**A380 South Devon Link Road (Kingskerswell Bypass)**

**Public Inquiry**

**Devon County Council's Response to  
Proof of Evidence on behalf of Three Corner Plantation Limited**

**(Obj 71): OBJ/TCPL(71)/P/1**

**Drawing HEX43444A/SKC/936A**

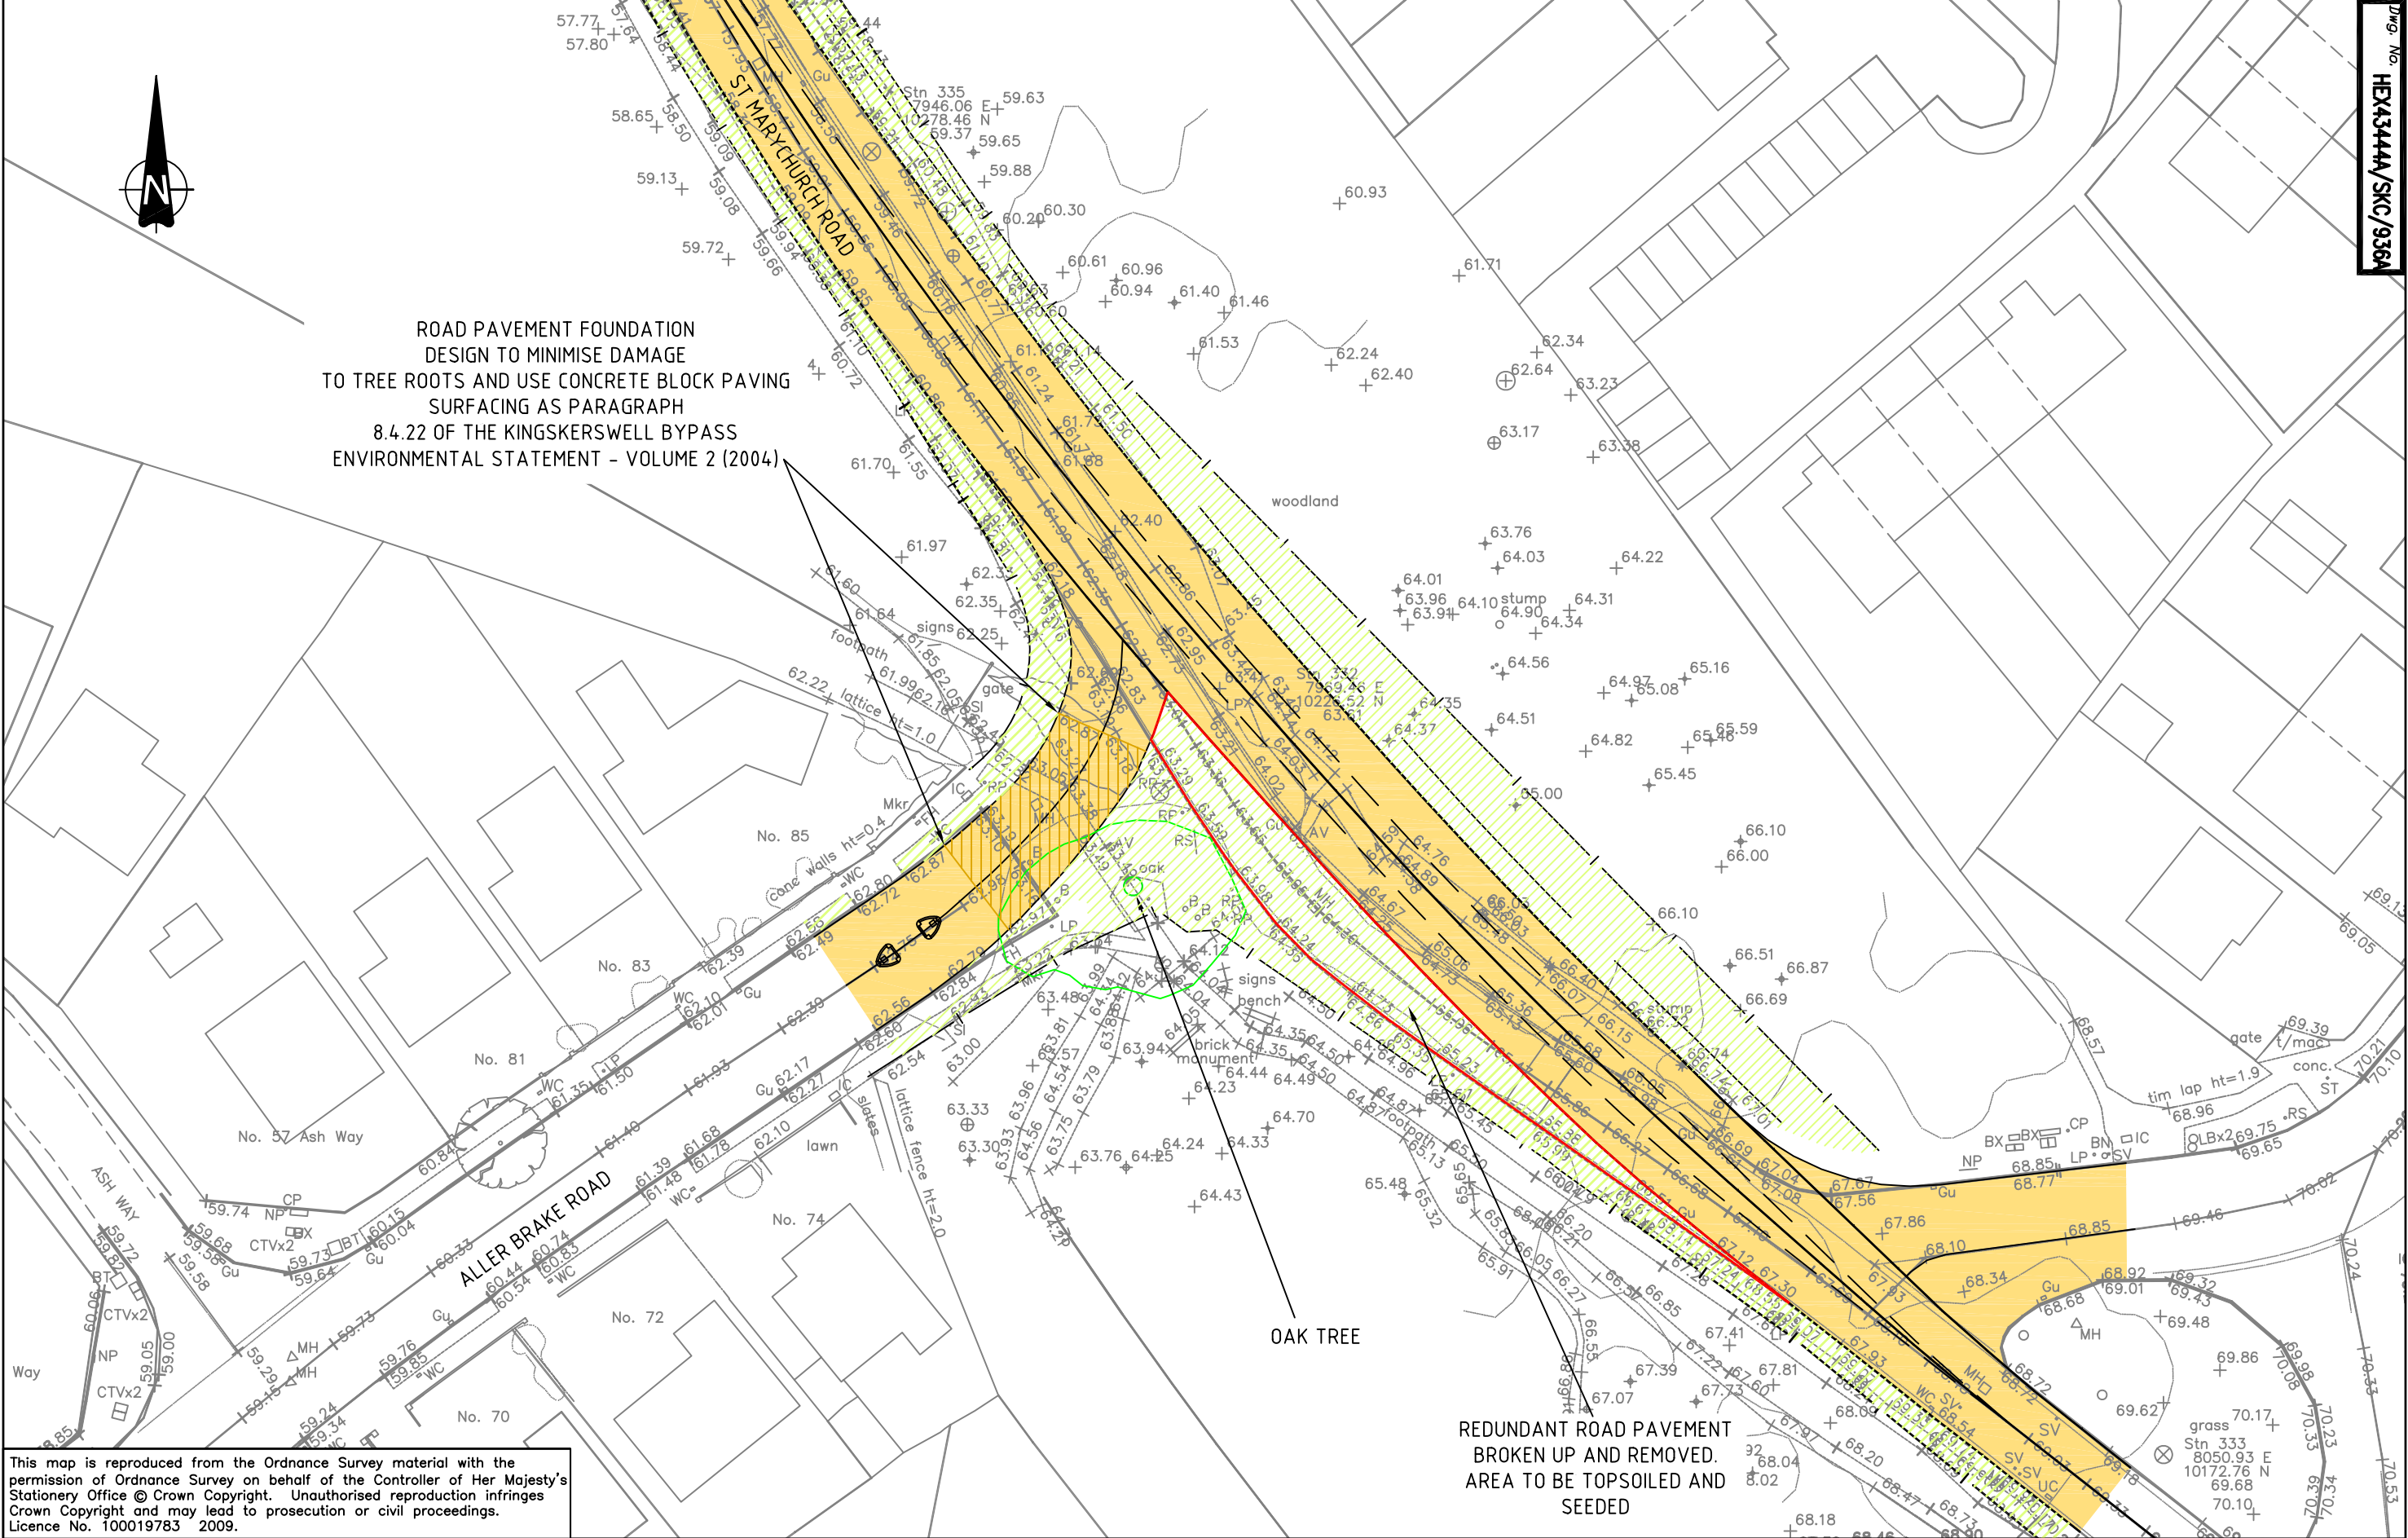
- 4.1 This tree is shown in **DCC/A2/6** in Photograph 30 on Figure LA 30. The proposed junction arrangement and re-instatement of redundant carriageway is shown on the attached drawing HEX43444A/SKC/936 included at Appendix 1.

ROAD PAVEMENT FOUNDATION  
 DESIGN TO MINIMISE DAMAGE  
 TO TREE ROOTS AND USE CONCRETE BLOCK PAVING  
 SURFACING AS PARAGRAPH  
 8.4.22 OF THE KINGSKERSWELL BYPASS  
 ENVIRONMENTAL STATEMENT - VOLUME 2 (2004)

REDUNDANT ROAD PAVEMENT  
 BROKEN UP AND REMOVED.  
 AREA TO BE TOPSOILED AND  
 SEED

4.7 It is clear that all necessary measures will be put in place to ensure the survival of this ecologically important tree.
